STAFF RECOMMENDATION

1413 Russell Street

February 15, 2012

Application: Infill

ARCHITECTURAL SITE PLAN

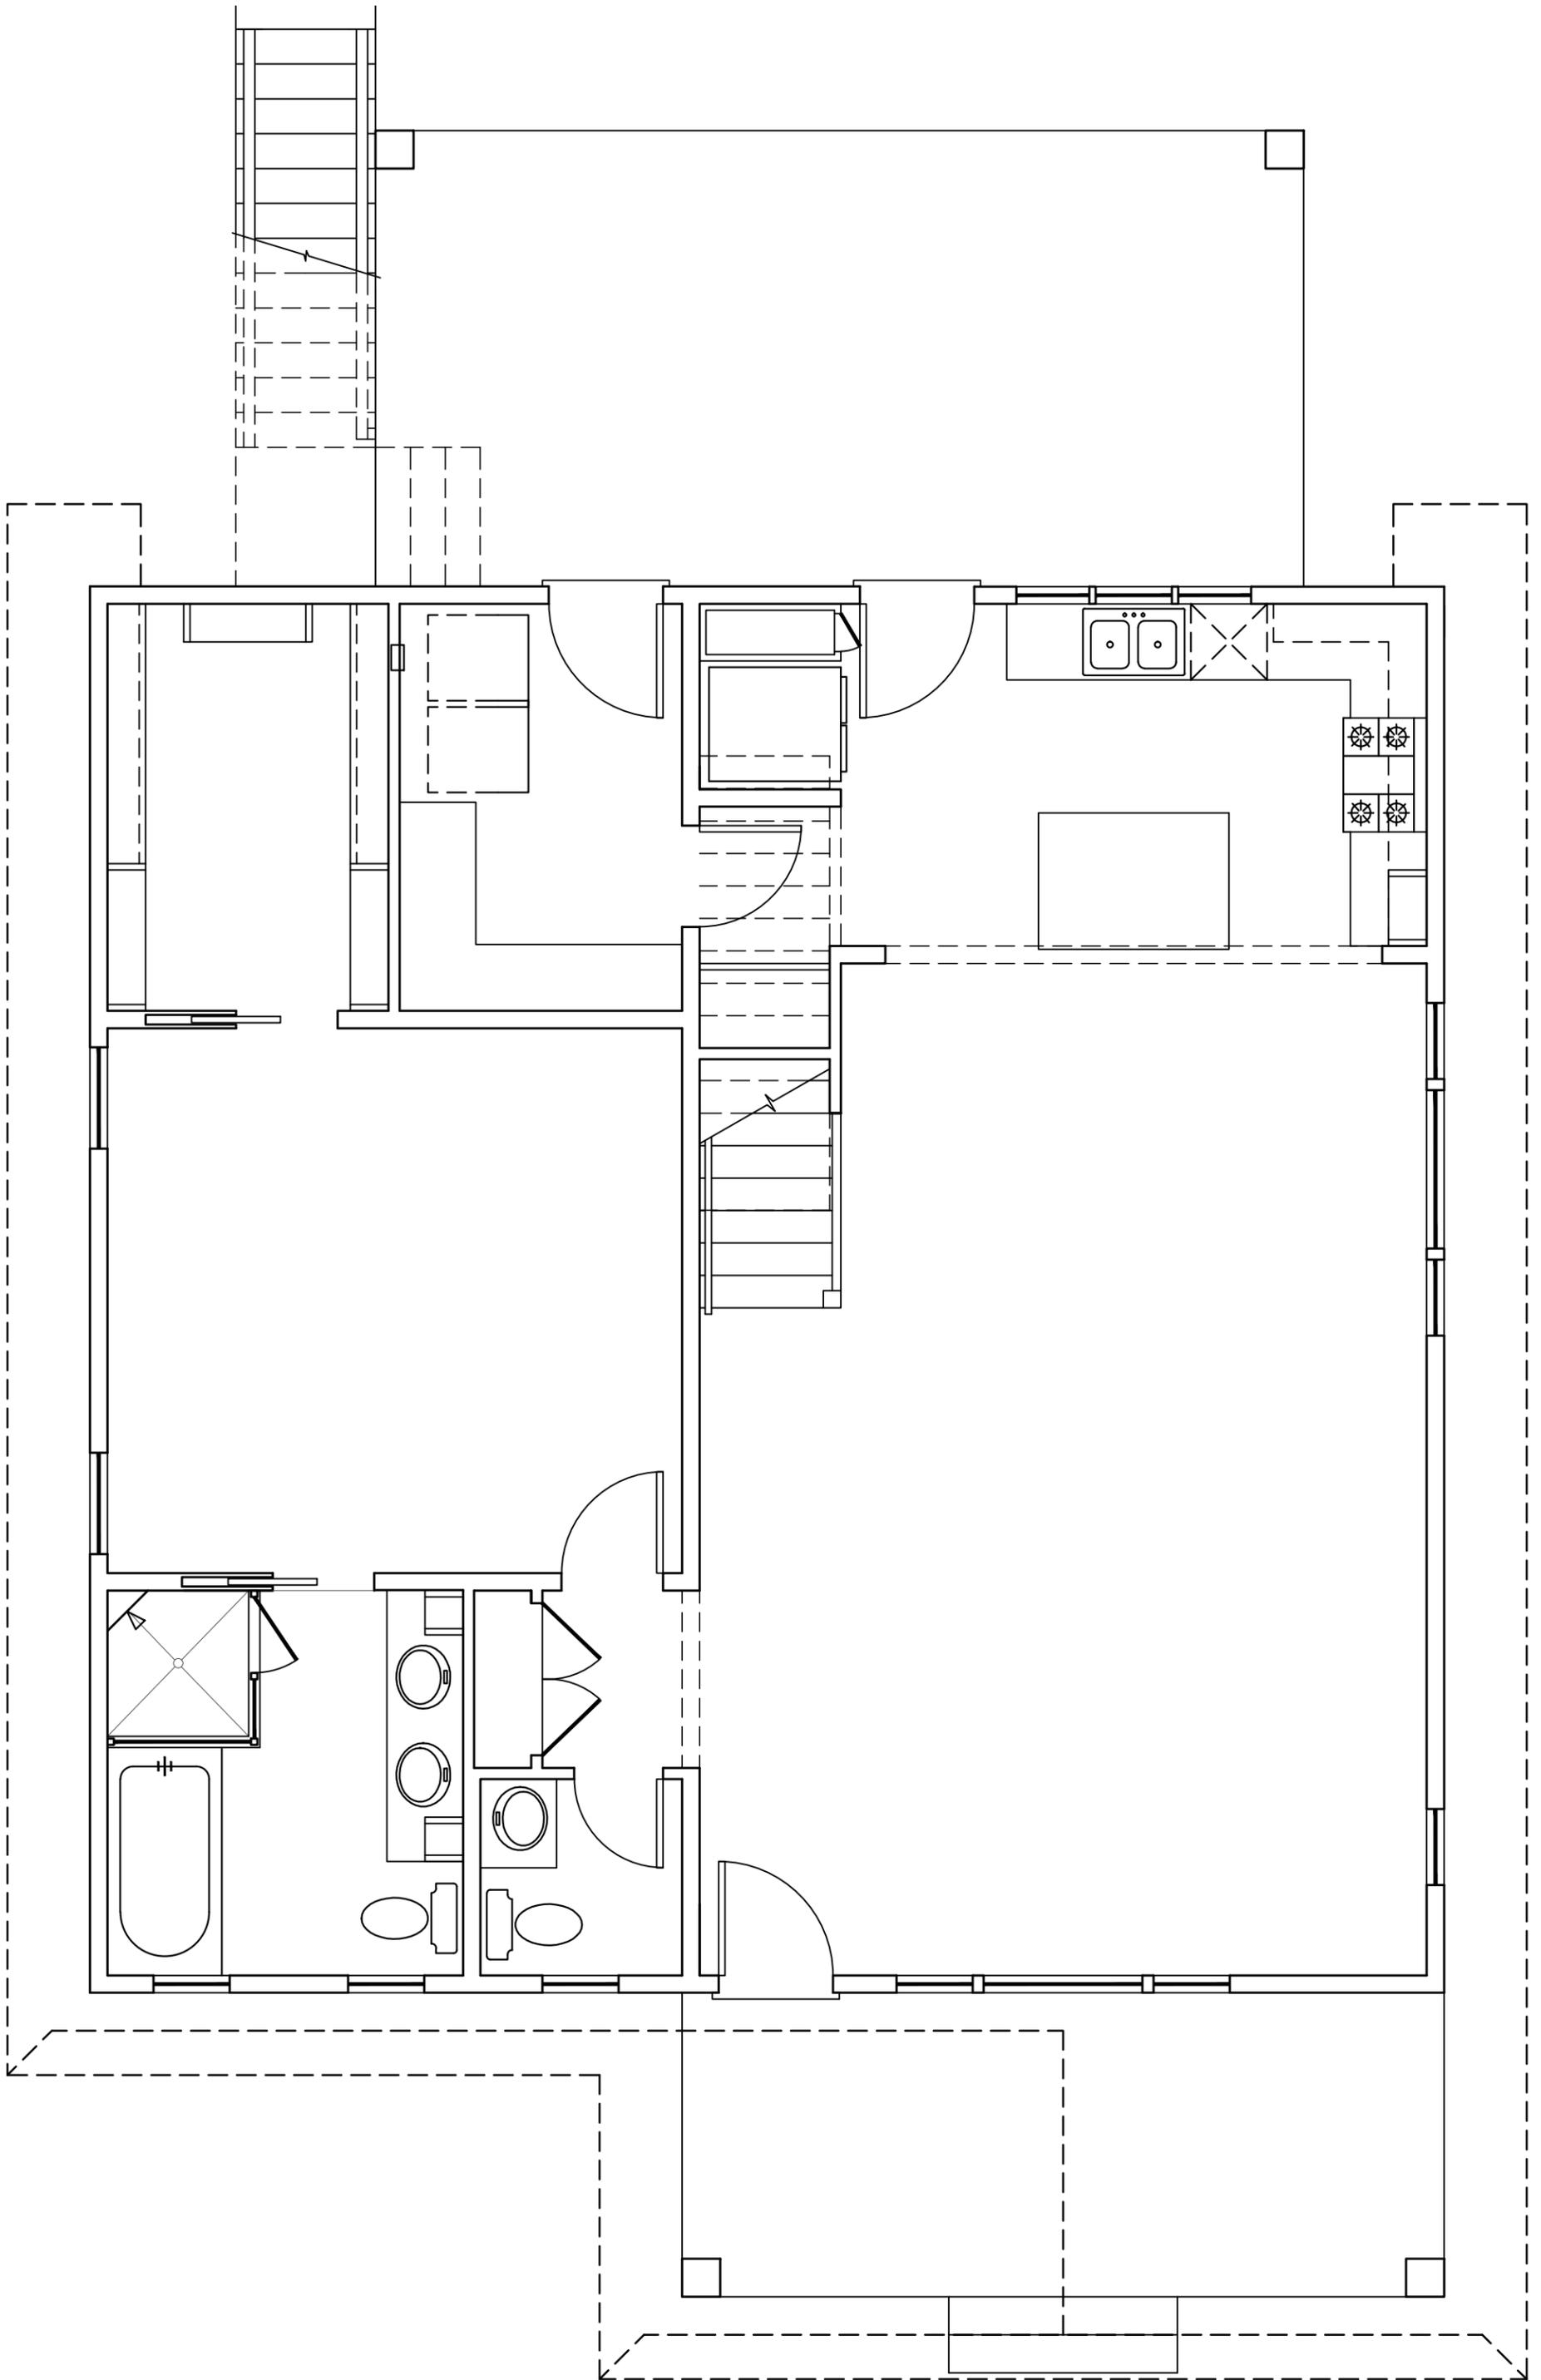
The house will be nearly square with a thirty-five foot, six inch (35'-6") wide front elevation, running thirty-seven feet (37') deep into the lot. The house will have a front setback of forty feet (40') to the front of the porch, which would approximately match the setback of the nearest historic structure. The house will be centered on the lot with seven foot (7') setbacks on each side. These setbacks meet the current zoning regulations, and maintain the rhythm of spacing established by historic houses in the area. In this aspect the proposal meets guideline II.B.3 (Setbacks and Rhythm of Spacing).

The width of this house will be similar to the adjacent contributing structure on the right and two other contribution structures on the block. The recent infill at 1409 Russell Street is only twenty feet (20') wide, but it would likely have been wider if not prohibited by an easement on the property.

FRONT ELEVATION

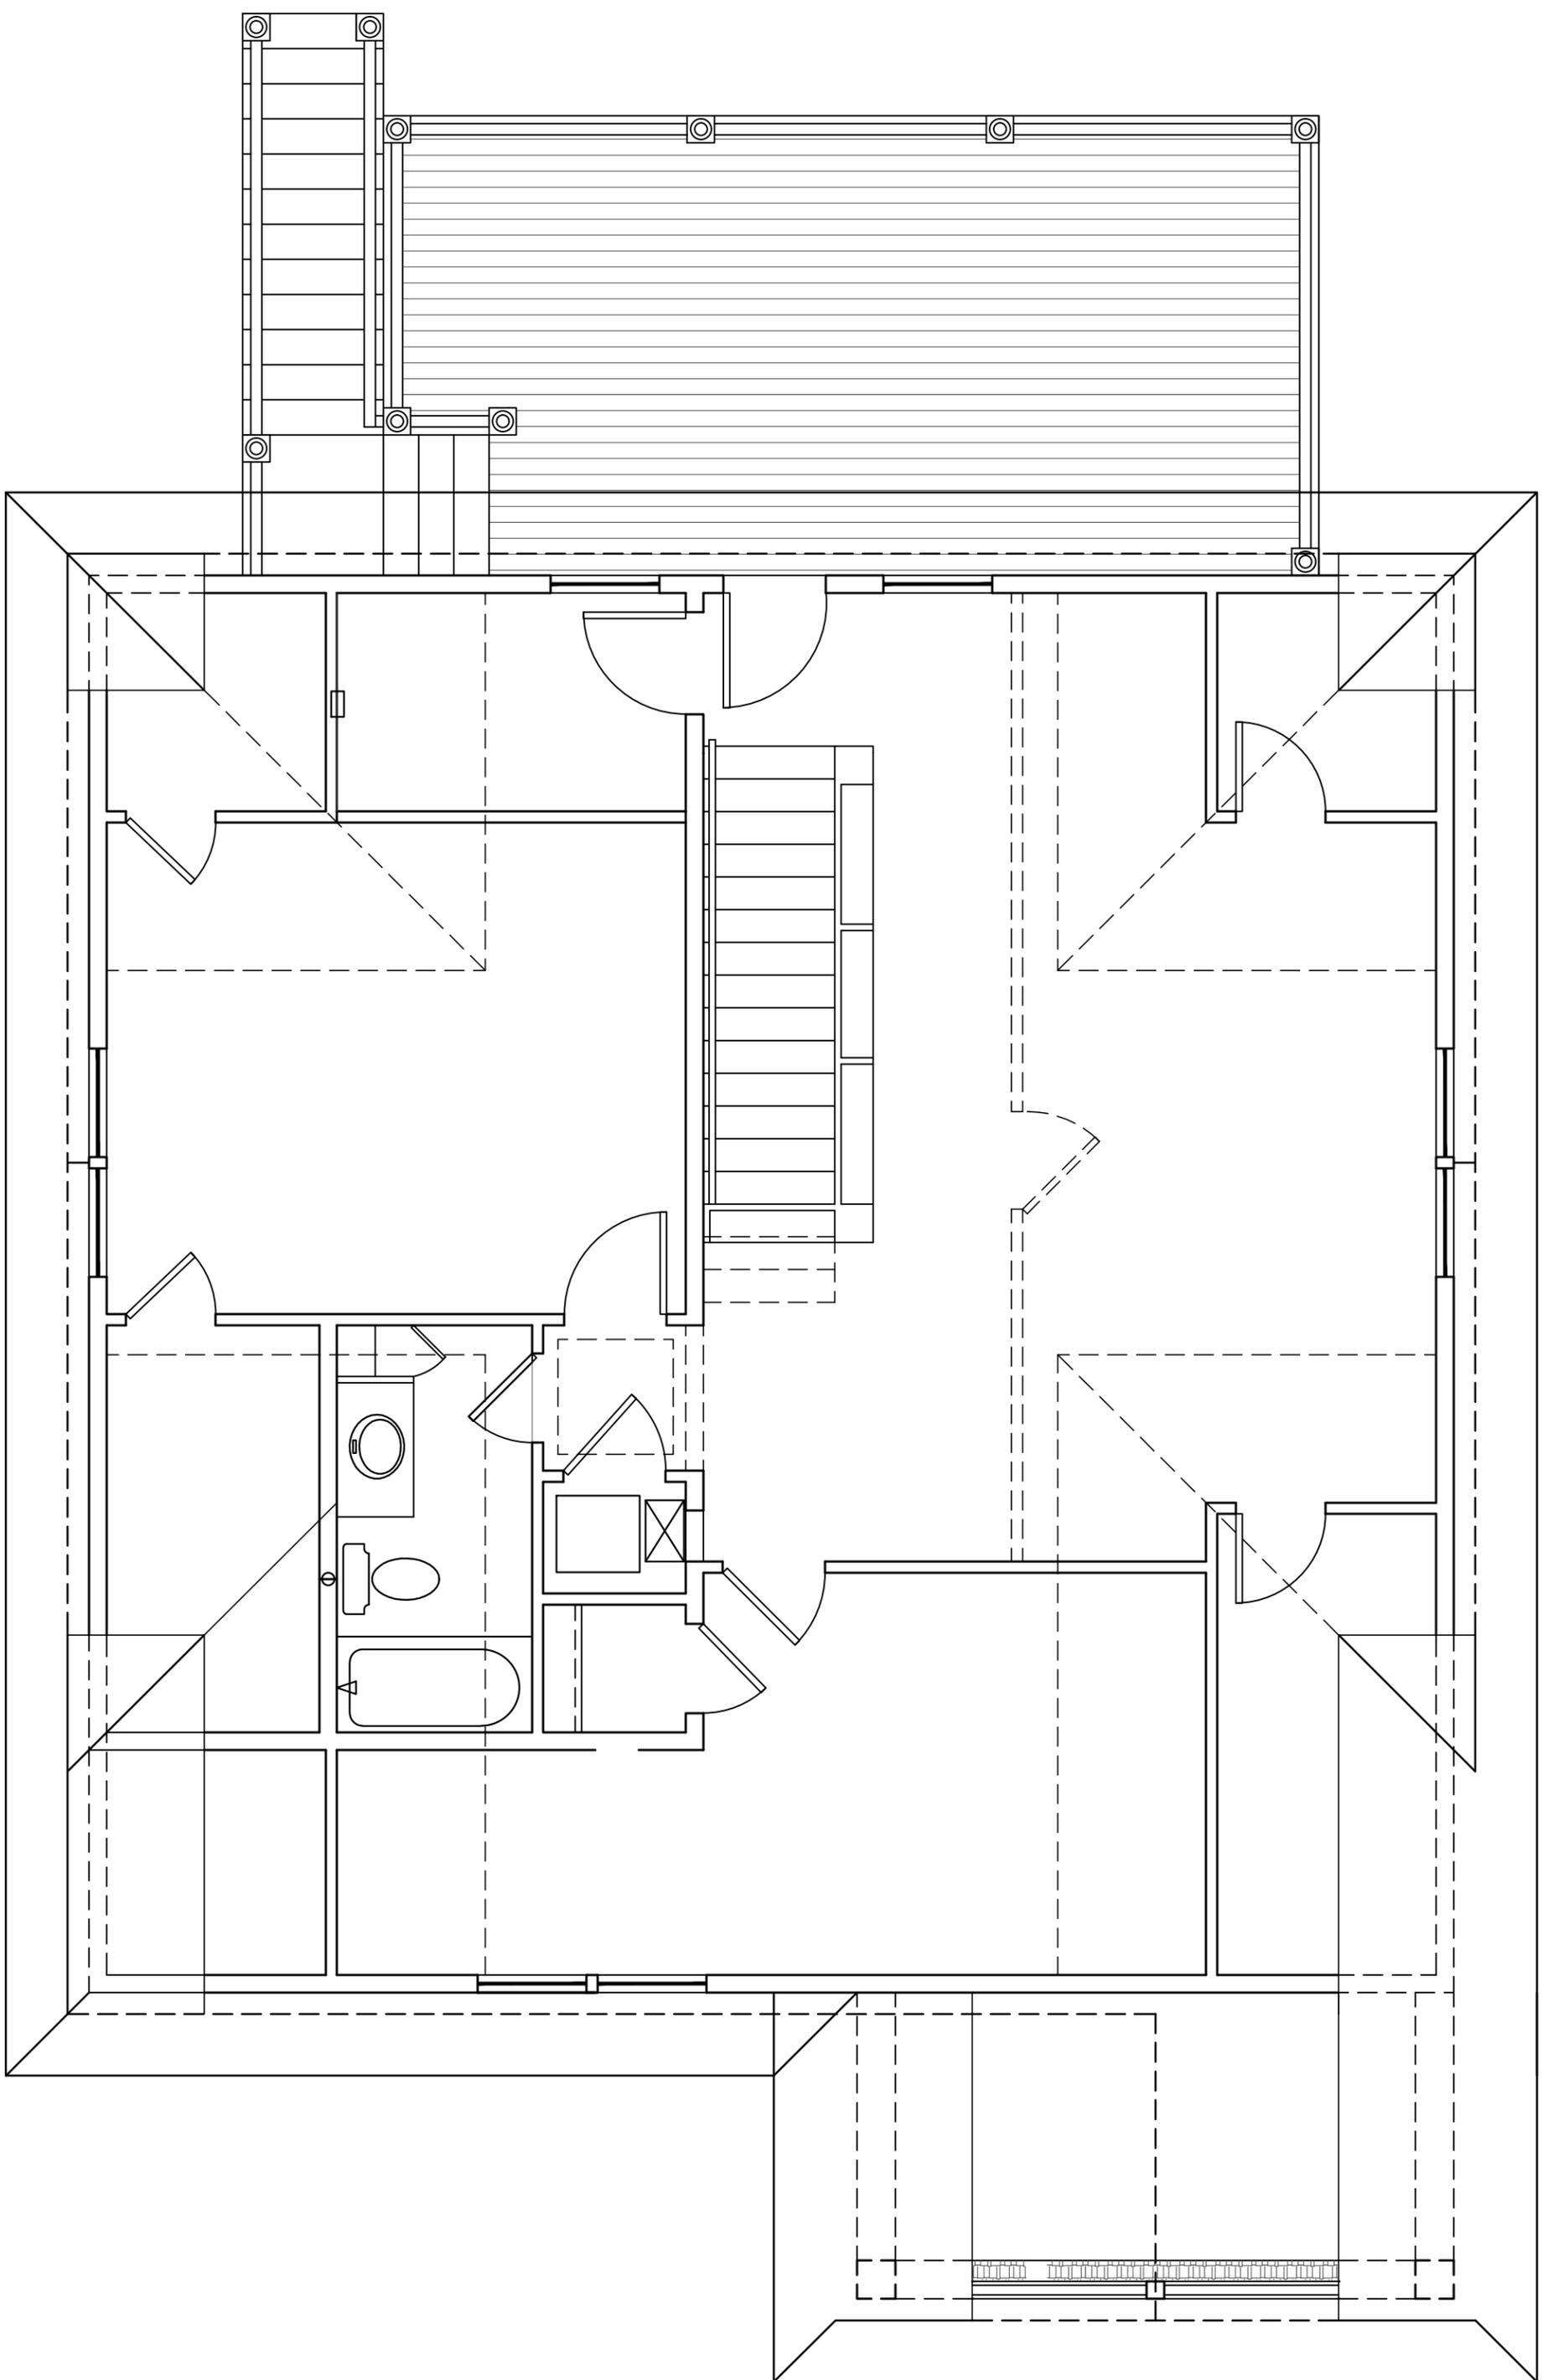
The windows on the front and side elevations are roughly twice as tall as they are wide, and the openings are spaced in a manner consistent with historic houses in the area. The upper story windows on the front elevation are roughly one foot taller than the first story windows, whereas typically first story windows are taller than windows on upper floors. The front door will be in the center of the front elevation, balanced by sets of windows on either side. These openings meet guideline II.B.7 (Proportion and Rhythm of Openings).

1. The details of roof color and the material of the windows, front and rear porch floors, porch railings, as well as exterior appurtenances are to be provided and approved by staff before a permit is issued.
2. The first story windows on the front elevation shall be at least as tall, or taller, than the windows on the upper story.
